## The Hirwaun Generating Station Order

# APPLICATION TO MAKE A NON MATERIAL CHANGE TO THE HIRWAUN GENERATING STATION ORDER

<b>PINS Reference Number:</b>	EN010059
<b>Document Reference:</b>	NMC
<b>Regulation Number:</b>	Regulation 4
<b>Author:</b>	Hirwaun Power Limited

PLAN

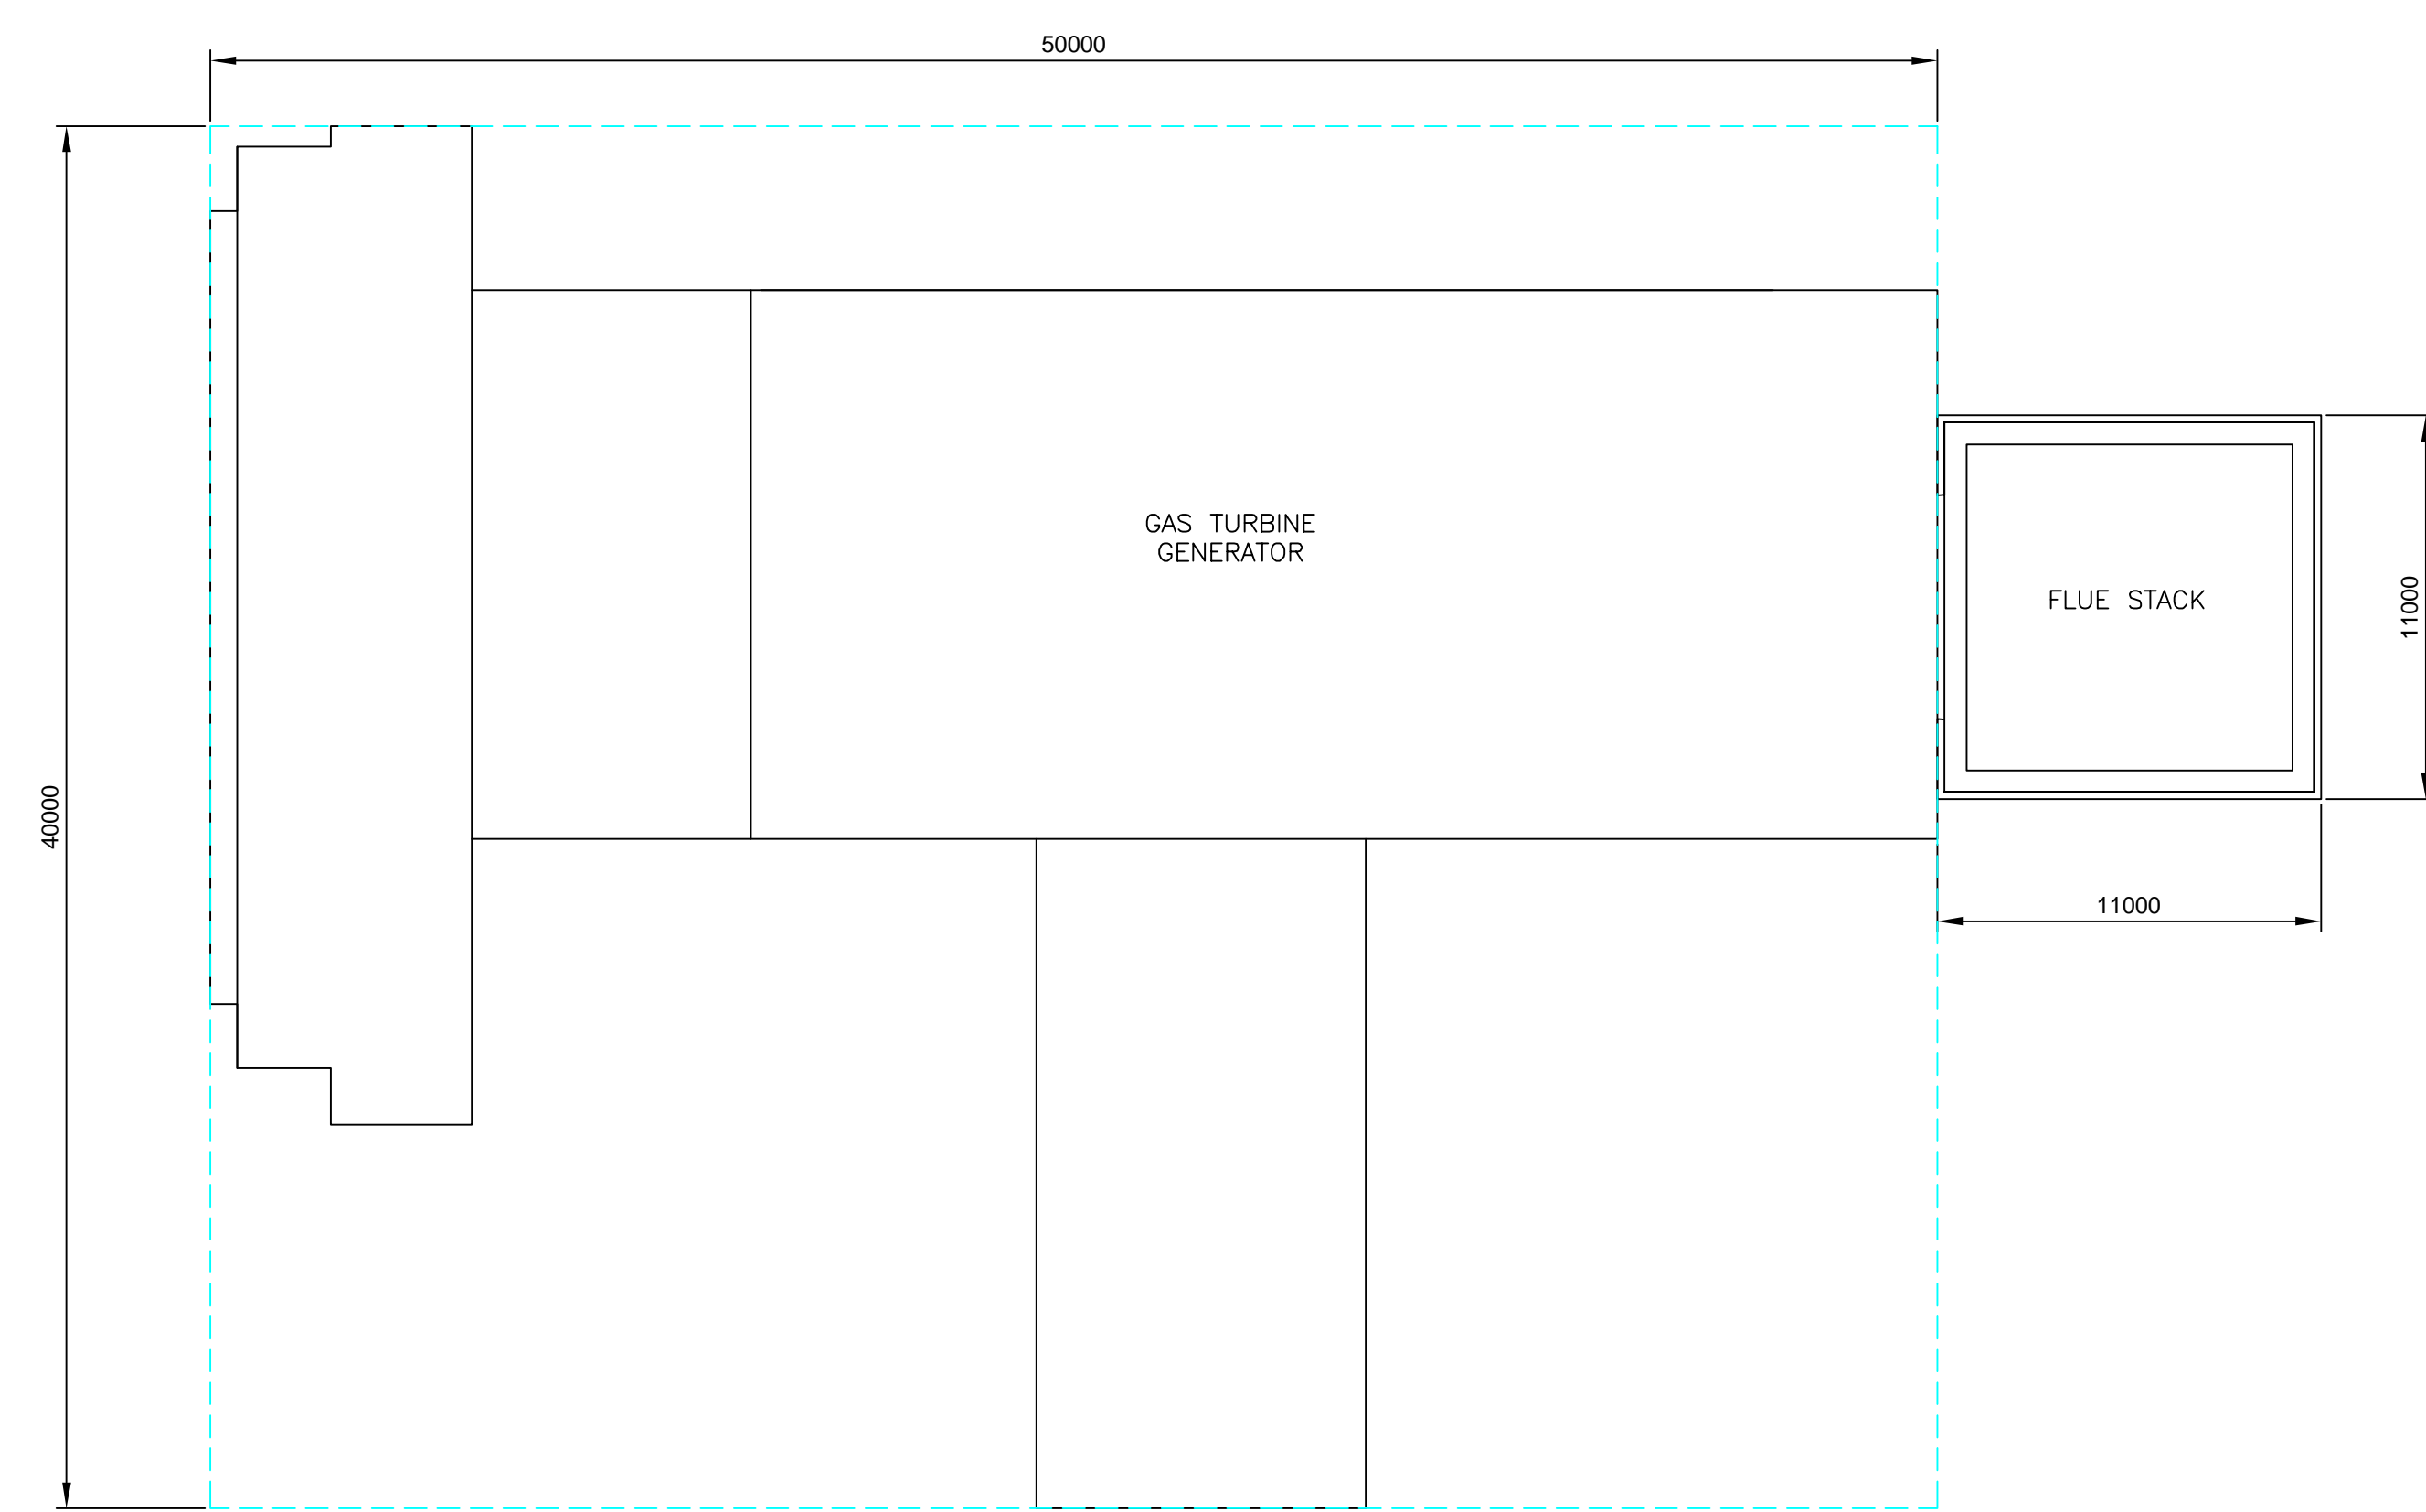
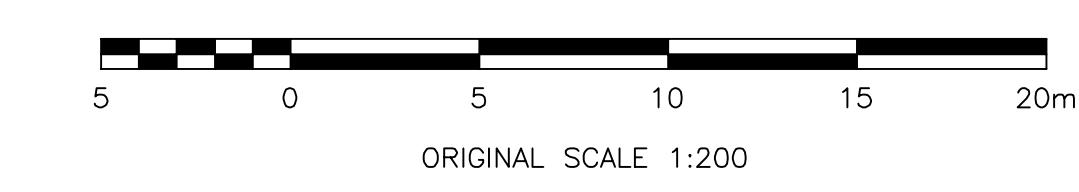
4.2.3 In summary, **for the one GTG scenario only**, there is a need to increase the length of the GTG from a maximum of 30 metres to 50 metres to accommodate the diffuser system elements of the GTG and the width from a maximum of 30 metres to 40 metres to accommodate the lube oil system. This would involve a change to Table 2 in Requirement 4, Schedule 2 of the Order. However, there would be no change in the overall footprint of the Power Generation Plant as show in Figures 5 and 6 of the Environmental Report (see Appendix Two).

(b) Figures 1, 2, 4, 5 and 6 of the Environmental Report show the proposed single GTG scenario and the proposed changes.

<b>Change Number</b>	<b>Building or Structure</b>	<b>Summary of what currently is authorised under the Order</b>	<b>Suggested Change</b>
One	Gas Turbine Generator (GTG)	<p>Table 2, Requirement 4, Schedule 2:</p> <p>Each gas turbine generator (where one or two gas turbine generators are constructed) (Part of numbered work 2A):</p> <p>Maximum height: 19 metres above 211 metres AOD</p> <p>Maximum length: 30 metres</p> <p>Maximum width: 30 metres</p>	<p>Amend Table 2, Requirement 4, Schedule 2 as set out in Appendix Four so as to permit the following parameters for a single GTG scenario:</p> <p>Maximum height: 19 metres above 211 metres AOD</p> <p>Maximum length: 50 metres</p> <p>Maximum width: 40 metres</p>
Two	Flue Stack	<p>Table 2, Requirement 4, Schedule 2:</p> <p>Each exhaust gas emission flue stack (part of numbered work 2A):</p> <p>Maximum height: 35 metres above 211 metres AOD</p> <p>Minimum height: 30 metres above 211 metres AOD</p>	<p>Amend Table 2, Requirement 4, Schedule 2, as set out in Appendix Four so as to permit the following parameters for a single GTG scenario:</p> <p>Maximum width: 11.0 metres up to and including a height of 16.5 metres above 211m AOD and 10 metres from a height of 16.5 metres above 211m AOD to a height of 35.0 metres above 211m AOD "</p>

Title: **BLACK START GENERATOR PLAN & ELEVATIONS Reg5(2)(o)**

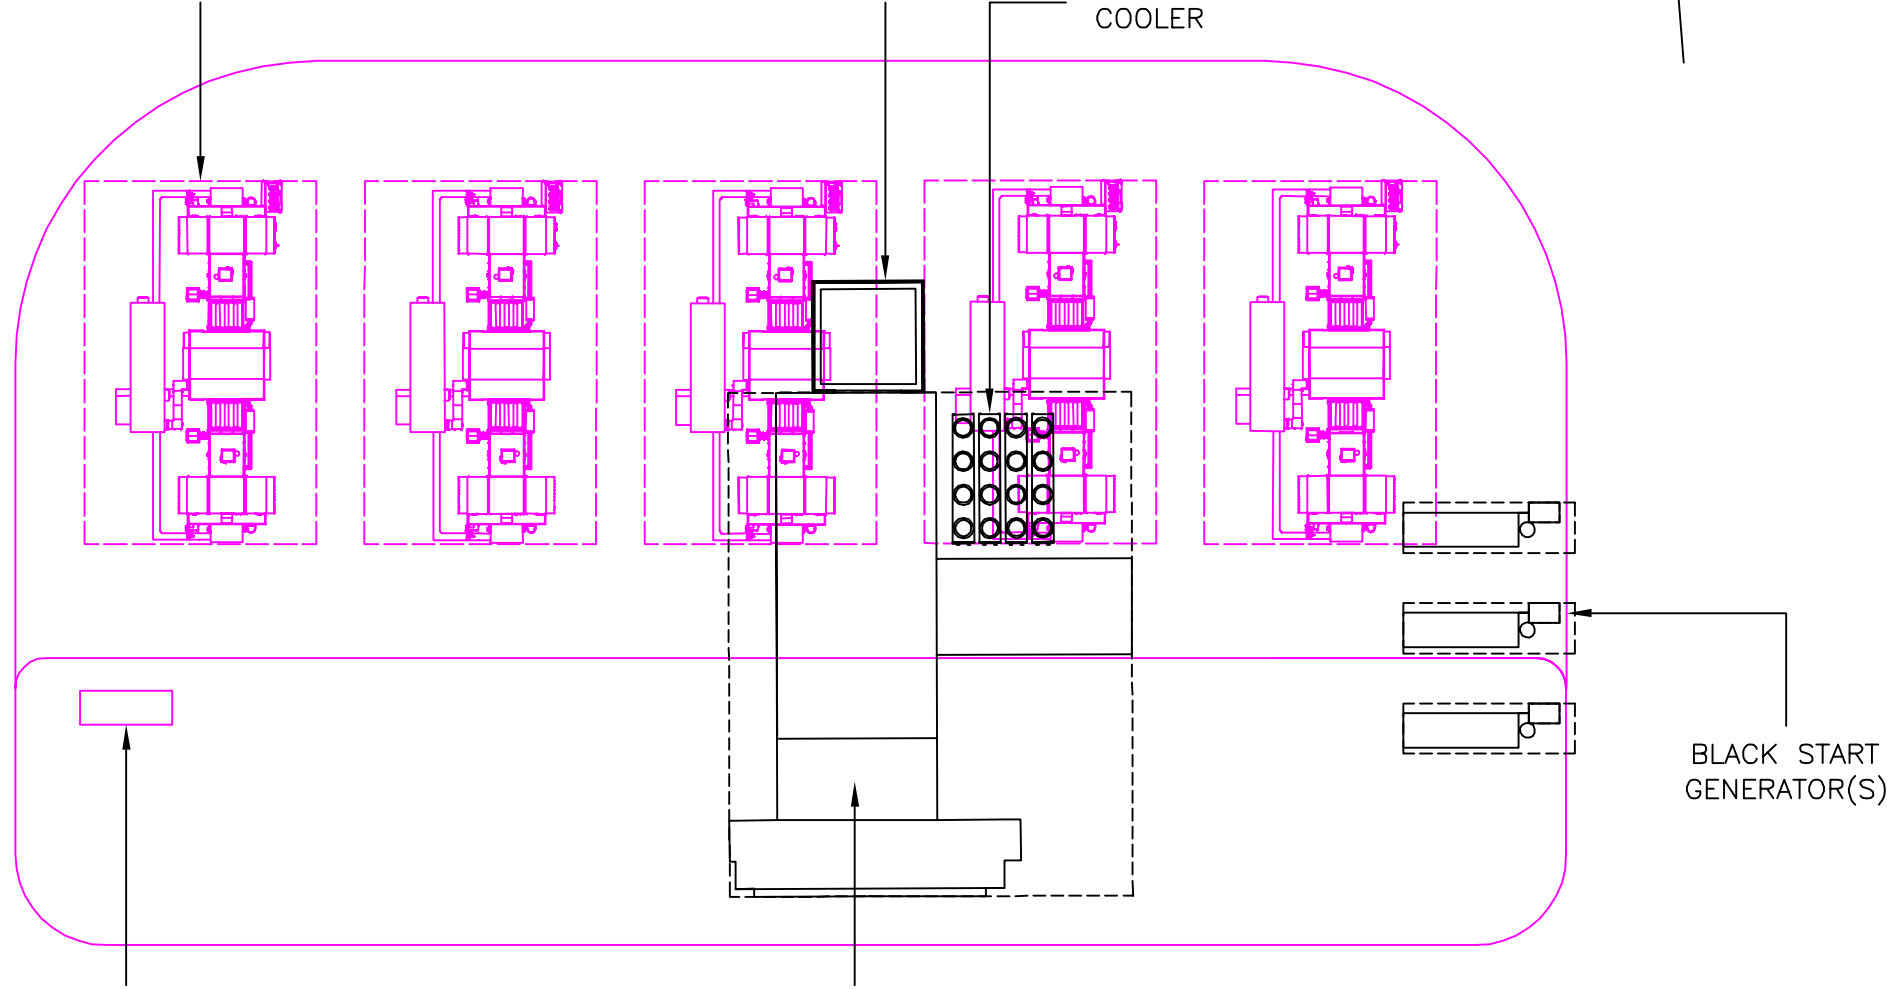
- (a) in the **single GTG scenarios only**, the number of black start diesel generators needs to increase from one to three. This would involve an amendment to Schedule 1 of the Order; and
- (b) in **all GTG scenarios**, the size of the black start diesel generators needs to increase in length from 13 metres to 17 metres. This would involve a change to Table 2 in Requirement 4, Schedule 2 of the Order.

- (a) The increase in the number of black start generators with the single GTG scenario compared to the single generator with the five GTG scenario means that the footprint of the black start generators will increase. However, due to other changes, the overall area of the Power Generation Plant will not increase.

- (b) Figures 1, 2, 4, 5 and 6 of the Environmental Report show the proposed single GTG scenario and the proposed changes.
- (c) The screening exercise set out in Chapter 4 of the Environmental Report identifies the potential for a change in the environmental effects predicted in the Environmental Statement. No change in impacts is predicted as a result of these changes for each of the environmental topics considered. In respect to air quality there will be no change in emissions as a result of the change which will also not affect any ecological receptors. There will be no change in noise and vibration levels. The change will not affect any heritage assets.

Change Number	Building or Structure	Summary of what currently is authorised under the Order	Suggested Change
		Maximum width: 10 metres	
Three	Black start diesel generator	<p>1. Schedule 1: Numbered work 2B authorises development comprising....(e) black start diesel generator</p> <p>2. Table 2, Requirement 4, Schedule 2: Black start diesel generator (part of numbered work 2B): Maximum height: 5.0 metres above 211 metres AOD Maximum length: 13.0 metres Maximum width: 5.0 metres</p>	<p>1. Amend Schedule 1, Numbered work 2B(e) as set out in Appendix Three.</p> <p>2. Amend Table 2, Requirement 4, Schedule 2 as set out in Appendix Four so as to permit the following parameters for all GTG scenarios:  Maximum length: 17 metres</p>

ELEVATIONS OF SINGLE GAS TURBINE SITE CASE FOR AMENDED DCO  
 ELEVATIONS OF FIVE GAS TURBINE GENERATORS SITE CASE FOR CONSENTED DCO  
 ----- MAX DIMENSIONS

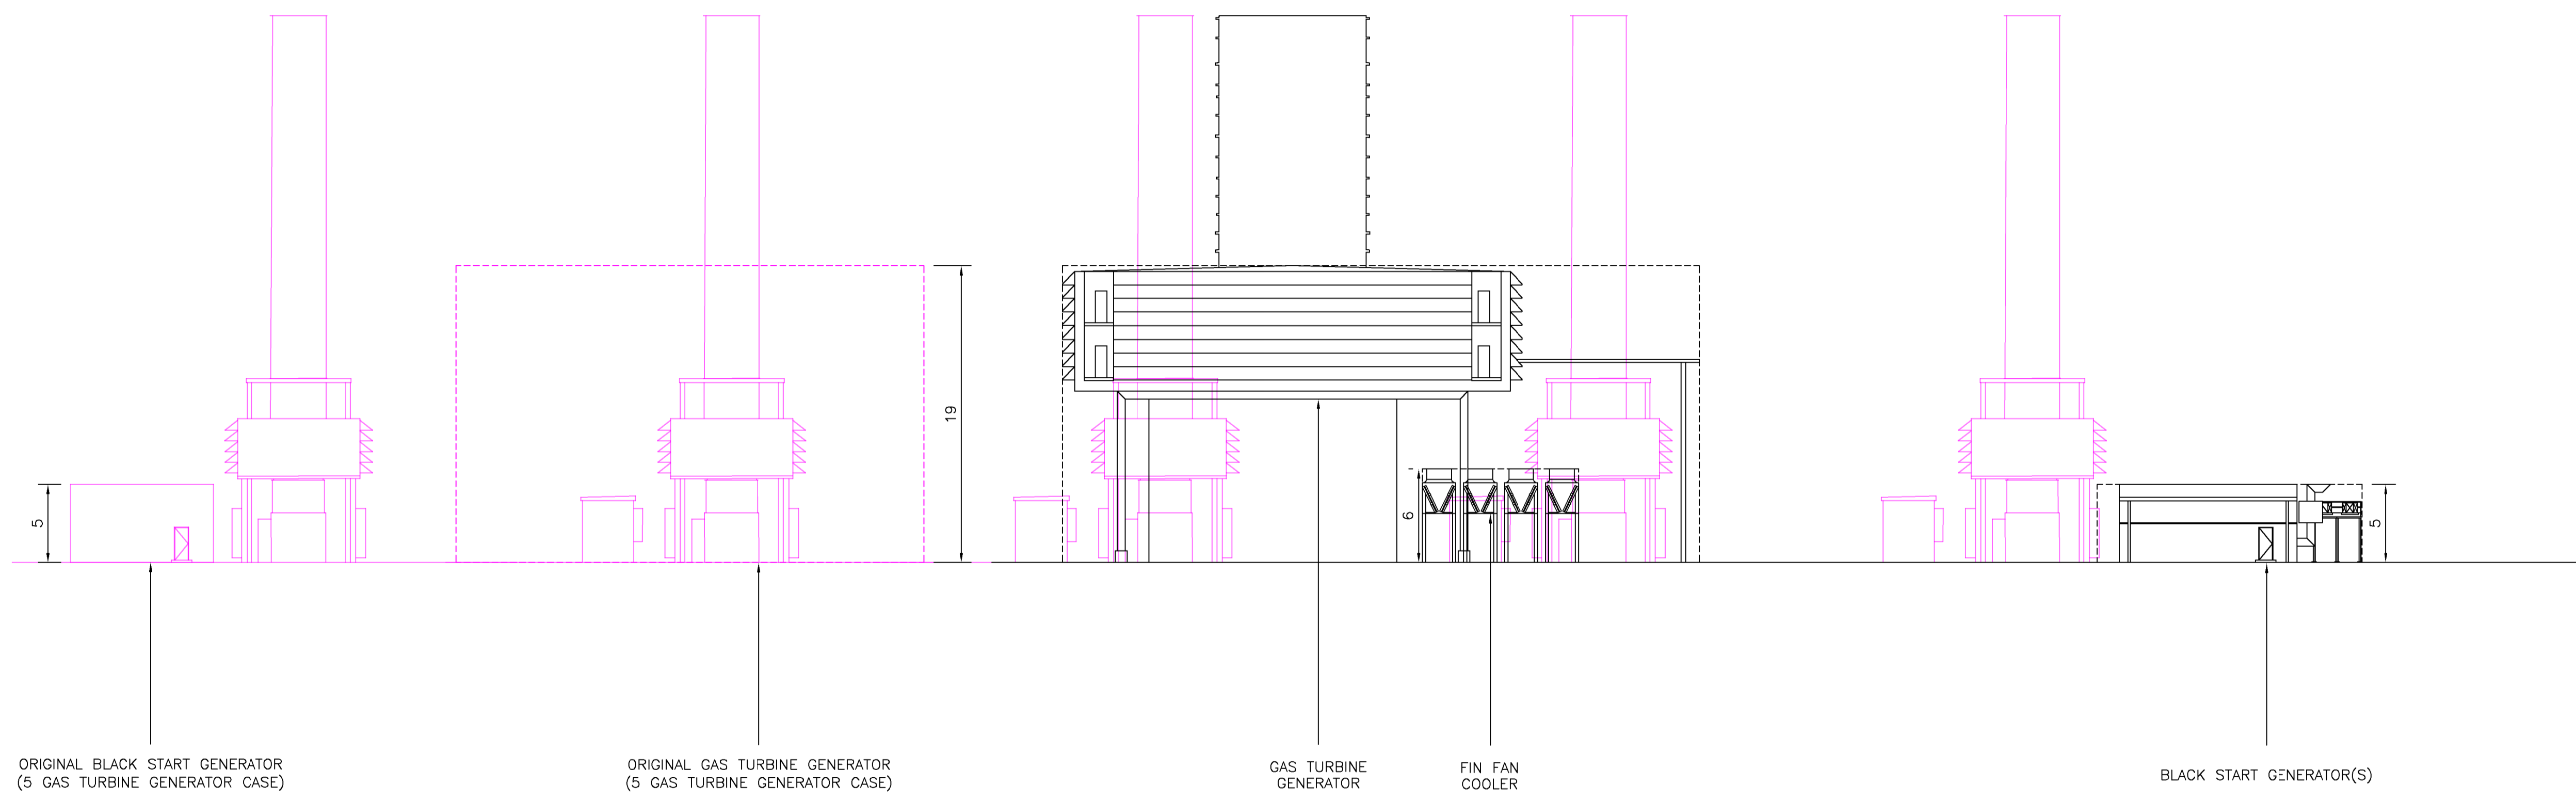
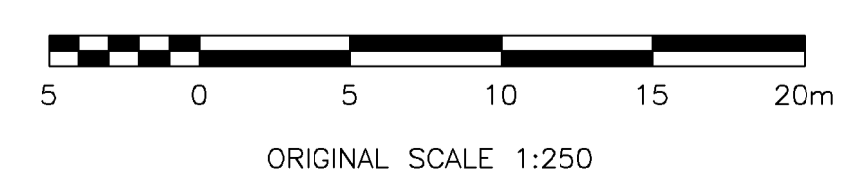
- 4.6.6 This change is non-material because:
  - (a) Whilst there would be an increase in the footprint of the GTG in the one GTG scenario, even with a stand-alone Fin Fan Cooler, the total built footprint of the single GTG scenario is smaller than the larger consented five GTG scenario (see Figures 5 and 6 of the Environmental Report).

- (b) Figures 1, 2, 4, 5 and 6 of the Environmental Report show the proposed single GTG scenario and the proposed changes. The screening exercise set out in Chapter 4 of the Environmental Report identifies the potential for a change in

Change Number	Building or Structure	Summary of what currently is authorised under the Order	Suggested Change
Five	Fin fan cooler	<p>Schedule 1:</p> <p>Numbered work 2E authorises development comprising...(k) other ancillary development</p>	<ol style="list-style-type: none"> <li>1. Amend Schedule 1, Numbered work 2E(K) as set out in Appendix Three.</li> <li>2. Amend Table 2, Requirement 4, Schedule 2 as set out in Appendix Four so as to permit the following parameters for a single GTG scenario: <ul style="list-style-type: none"> <li>Maximum height: 6 metres</li> <li>Maximum length 13 metres</li> <li>Maximum width 10 metres</li> </ul> </li> </ol>
Six	Switchyard/banking compound	<p>Schedule 1:</p> <p>Numbered work 2C authorises development comprising a switchyard/banking compound containing up to eight transformers, switchgear building and other plant required to manage the transmission of electricity</p> <p>Article 3(2) requires each numbered work to be situated in the numbered area shown on the Works Plans</p>	<ol style="list-style-type: none"> <li>1. Amend the Works Plans to increase the area covered by numbered work 2C and produce revision 4 of the works plans;</li> <li>2. Amend the definition of "works plans" in Article 2(1) to refer to "revision 4"</li> <li>3. Amend Table 1, Requirement 4, Schedule 2 of the Order to refer to "revision 4" of the works plans.</li> </ol>
